BLM SCALAR FIX -Based on findbhudda's original design:
<http://www.midibox.org/dokuwiki/doku.php?id=findbhudda>

Corrected blm-scalar v1.1.brd below & attached: [blm-scalar_v1.1.zip](#)

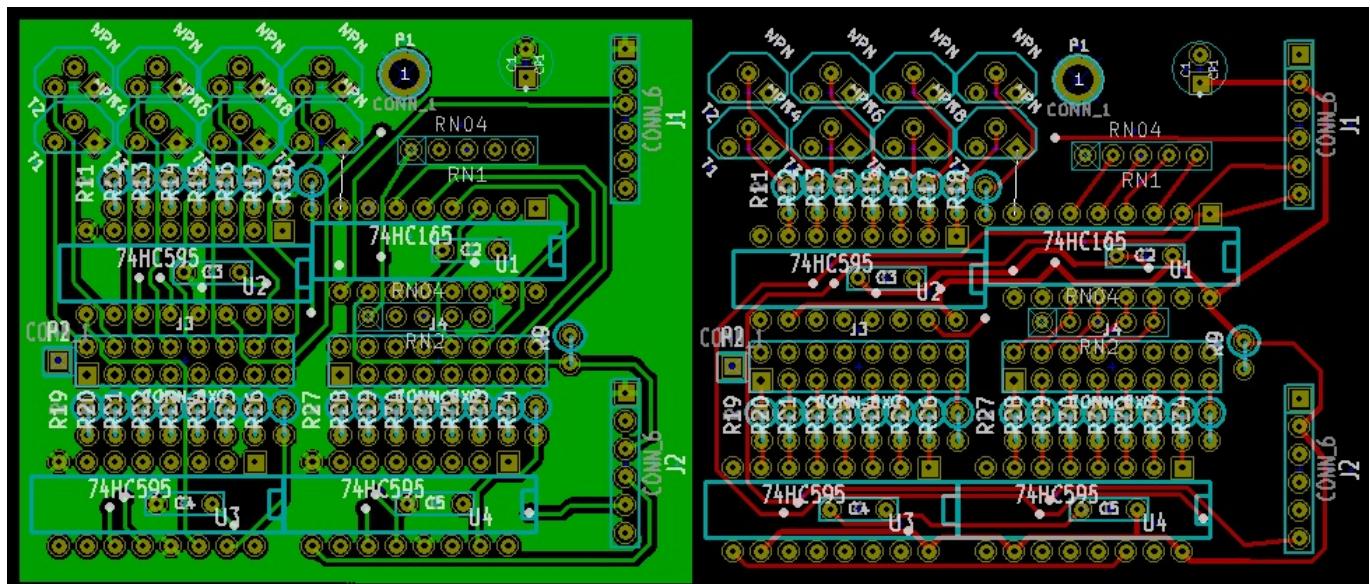
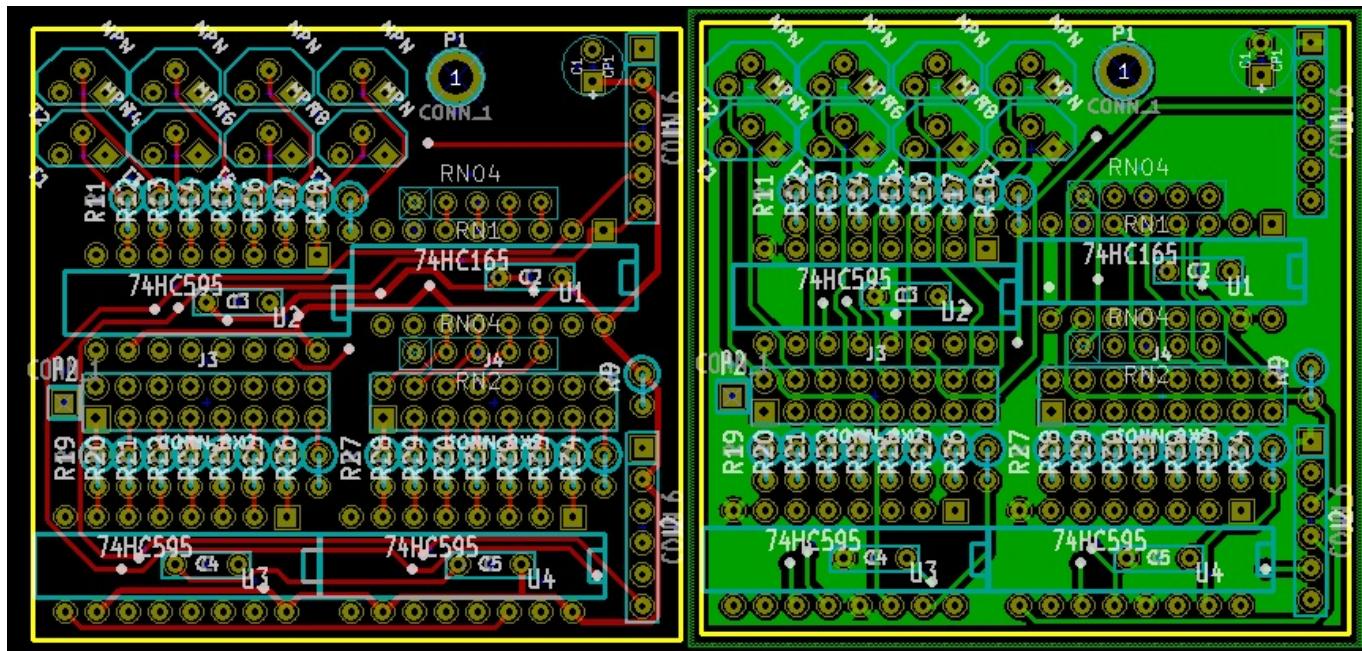
- blm-scalar.* contain an error. Pins I4-I7 are mirrored. This is easily fixed with a connector modification, and the blm-scalar module seems to work as intended.
- blm-scalar v1.1 attempts to fix this error. Moved connectors J1, J2, Resistor Net 1 and R9 to make room for corrections.
